HUNTS POINT INTERSTATE ACCESS IMPROVEMENT PROJECT – CONTRACT 3

PIN X731.65, Contract D900055

Addendum #8

July 22, 2022

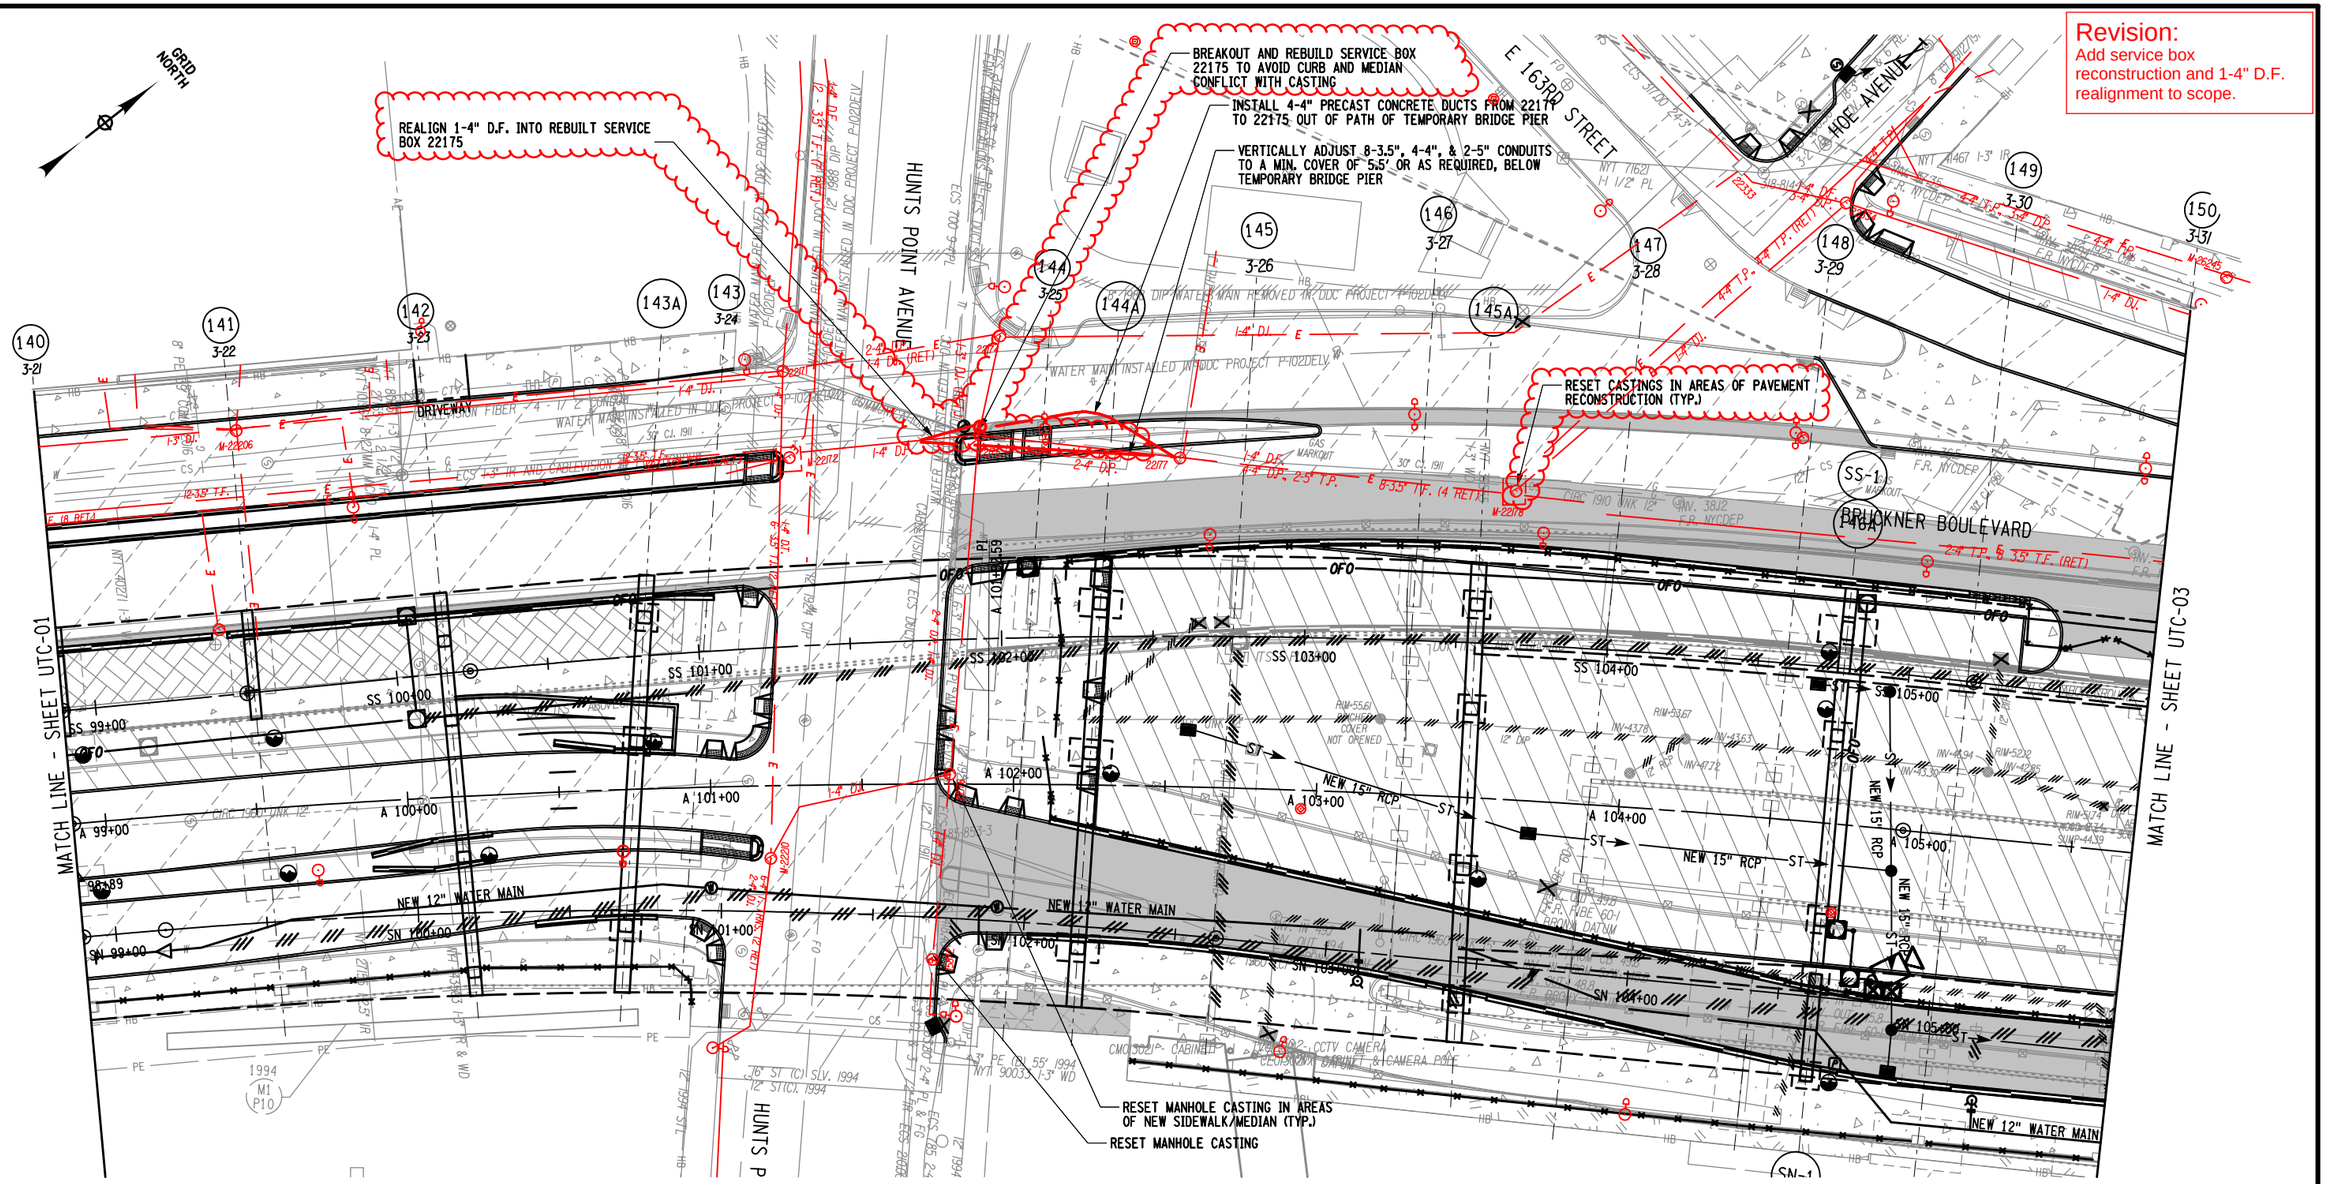
Revision:
Add service box reconstruction and 1-4" D.F. realignment to scope.

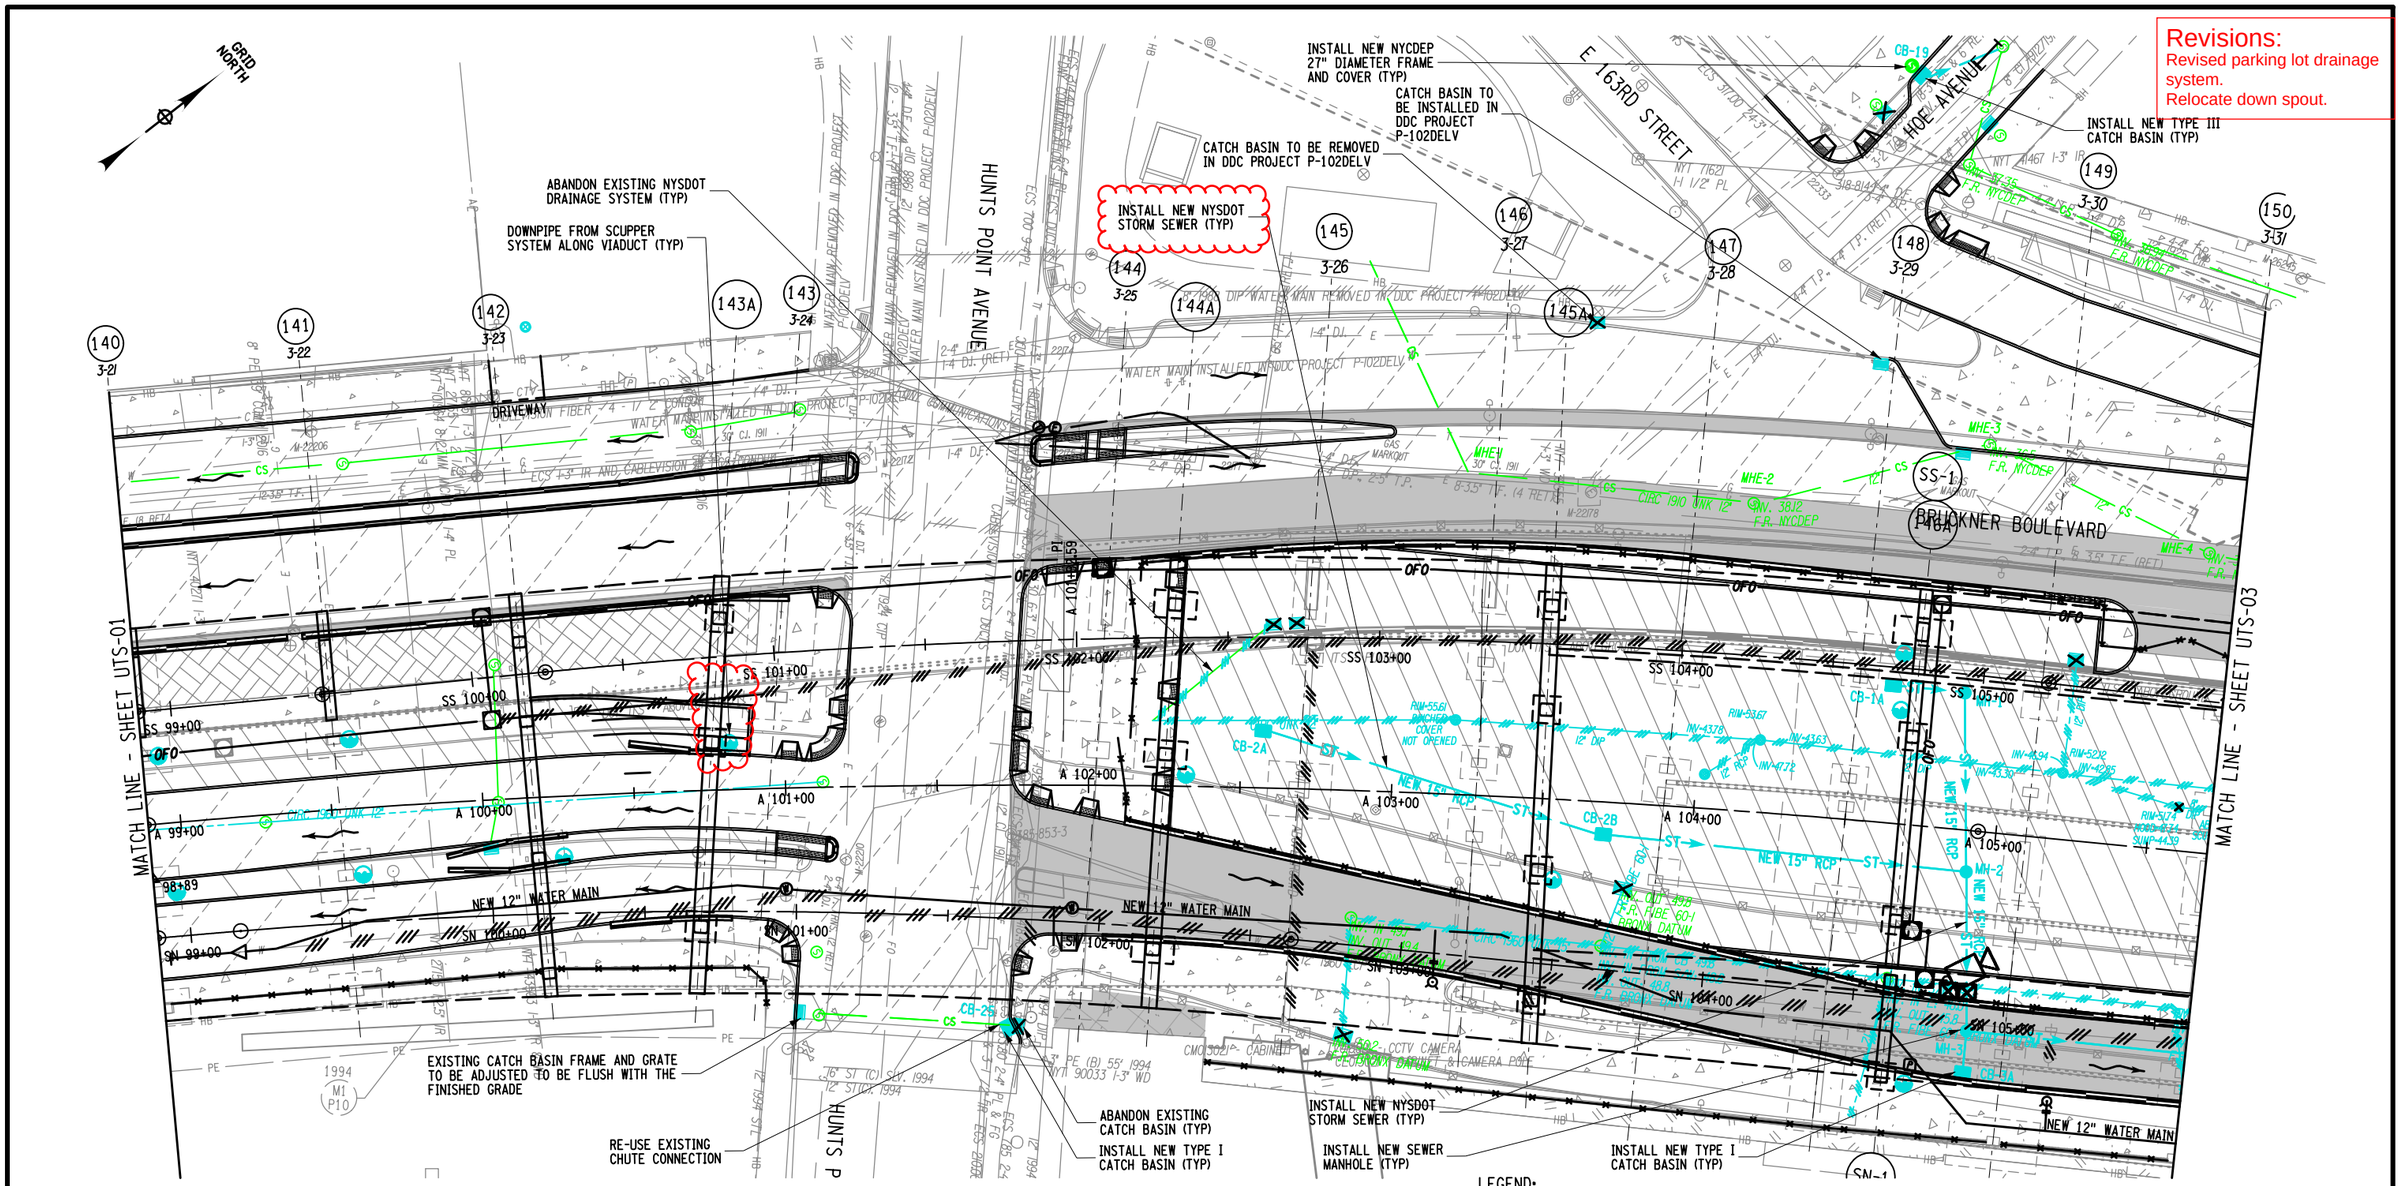
Revisions:
Revised parking lot drainage system.
Relocate down spout.

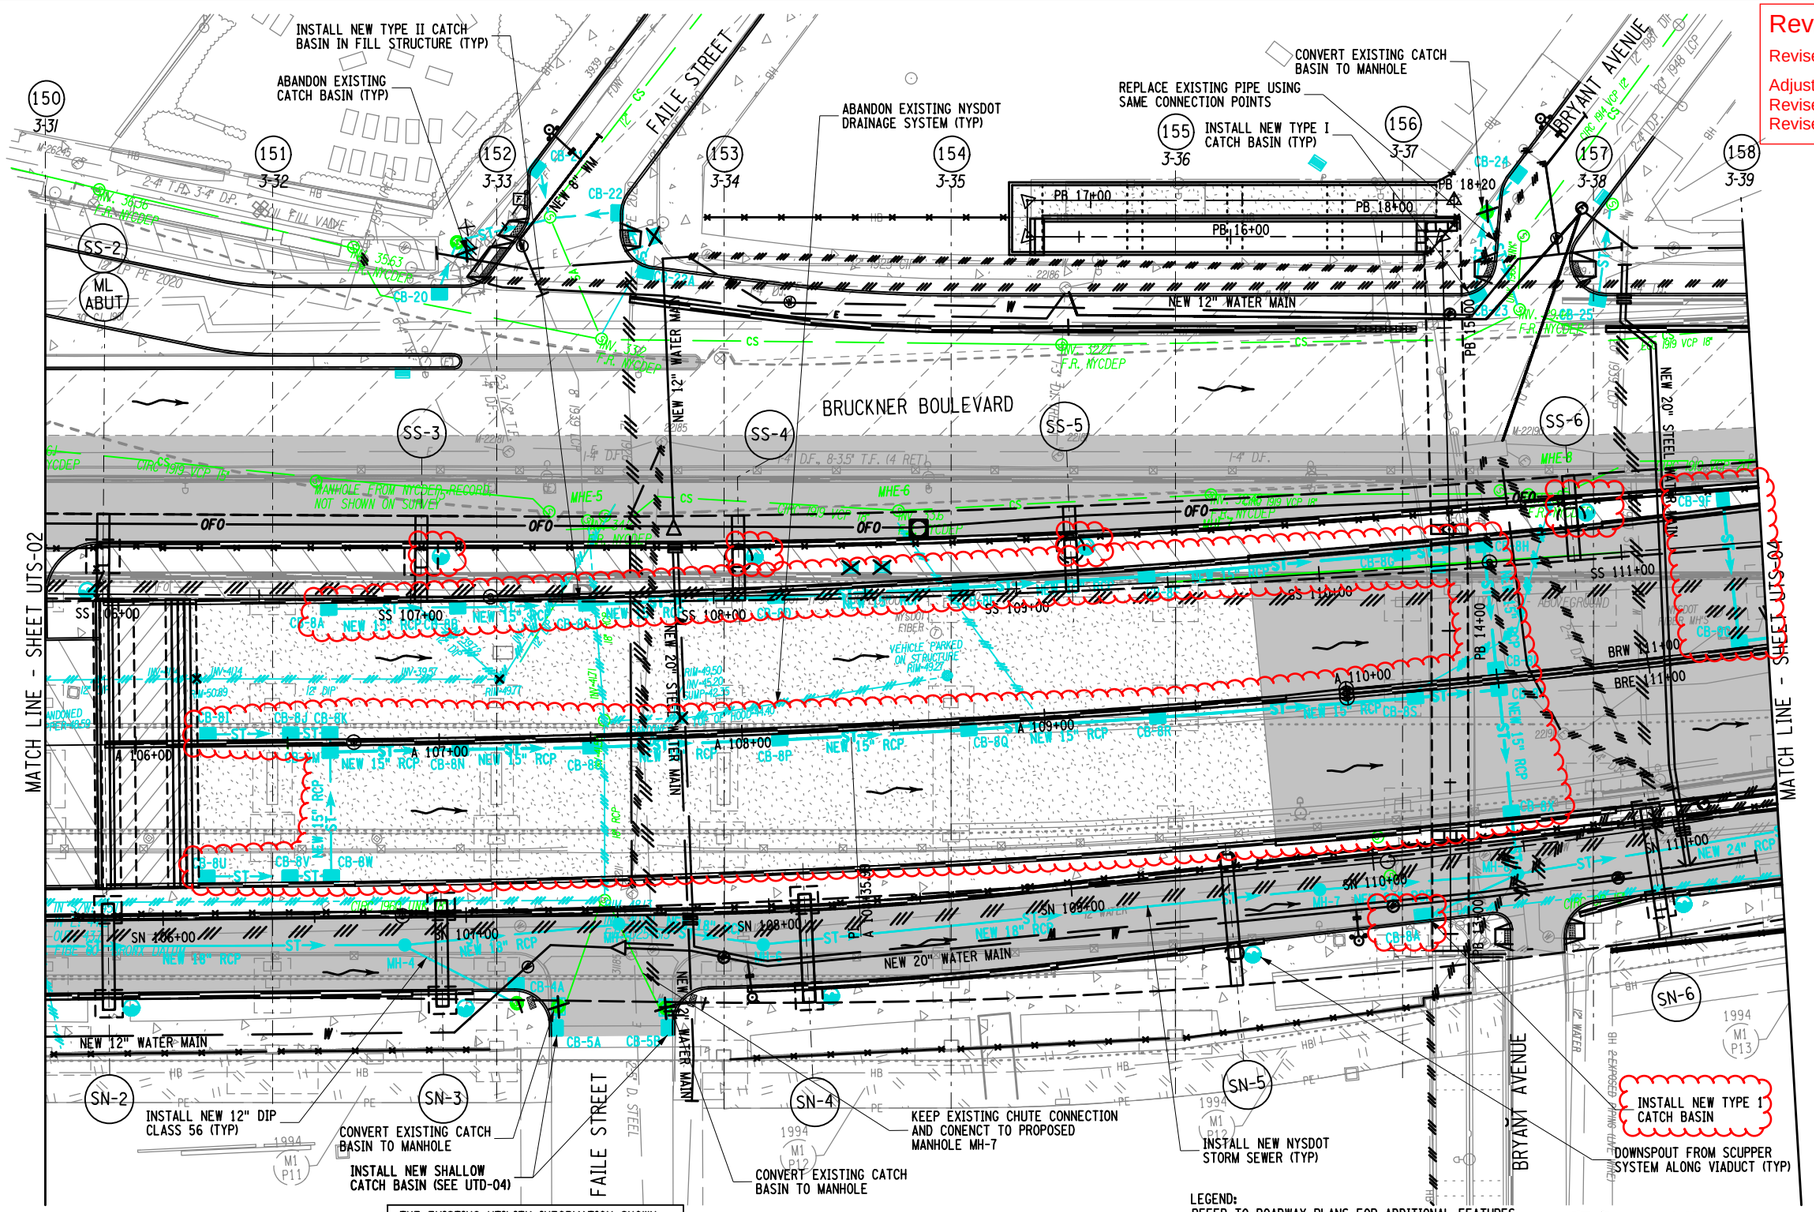
Adjusted downspout locations.
Revised to show CB-8B, CB-8C, connections.
Revise Expressway Drainage System.

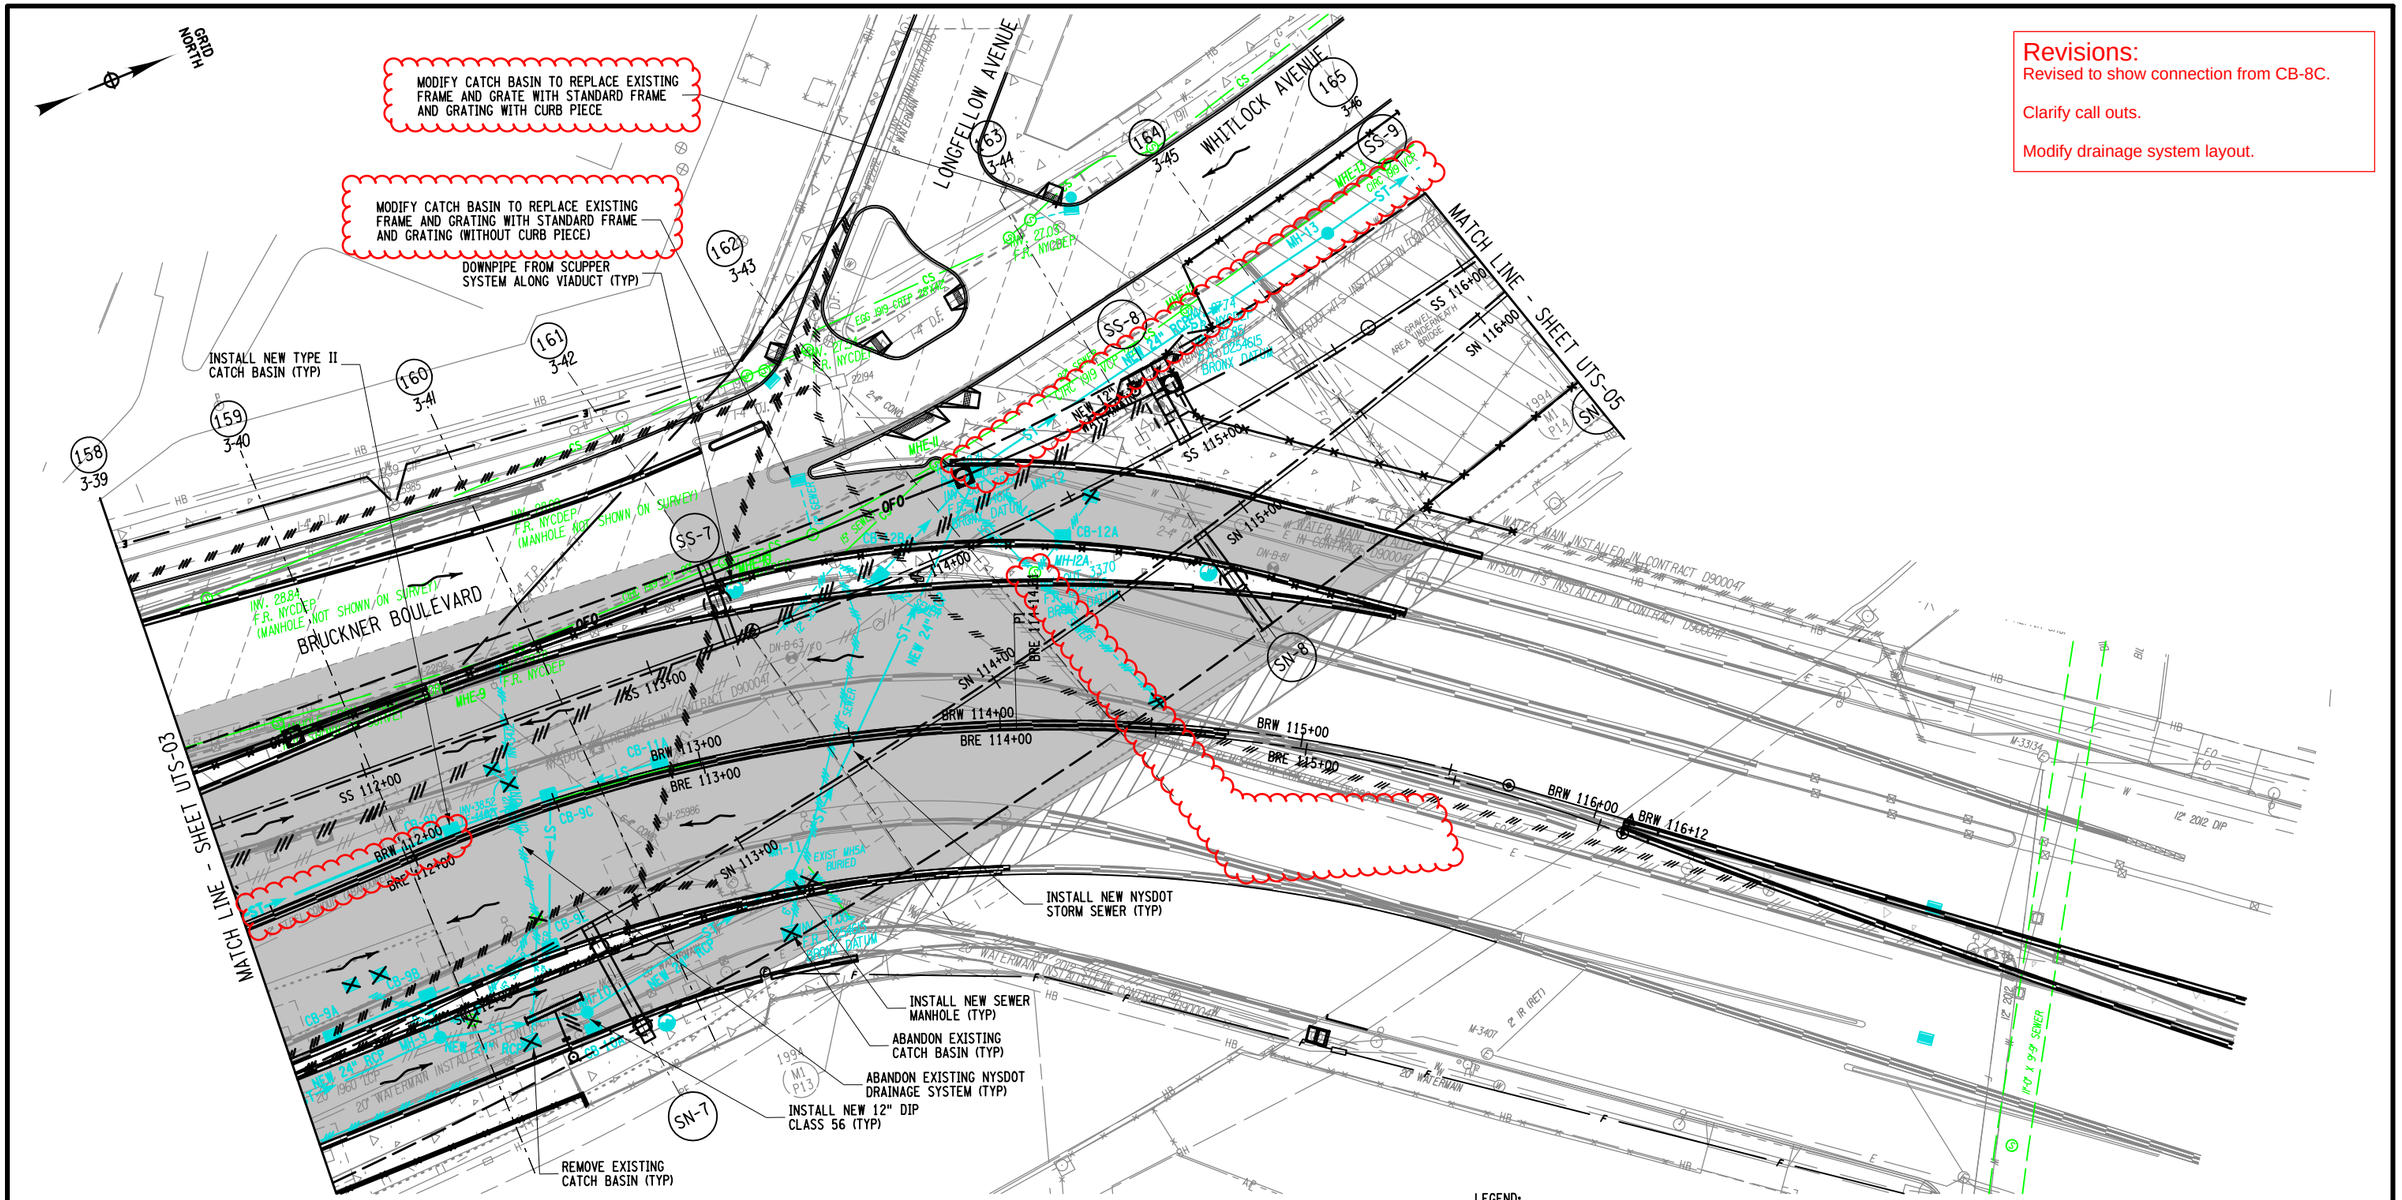
Revised to show connection from CB-8C.
